UNITED STATES PATENT AND TRADEMARK OFFICE

Office Action Summary

10/707,775

DETAILED ACTION

Fig. 2

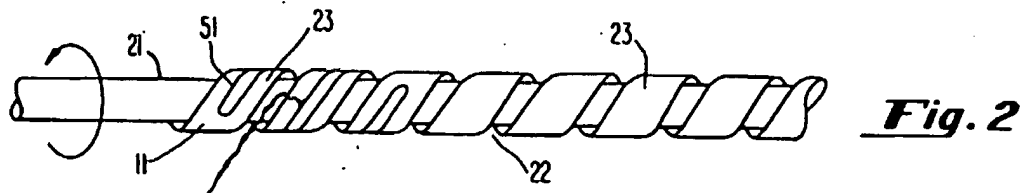
Figures 2, 3 and 4 above, illustrate the conventionality of the sensor is coupled to an end of the plastic cord. Additionally, the specification in column 5, lines 30-55, and in column 5, lines 7-29), expressly discloses a sensor that is coupled to an end of the plastic cord.
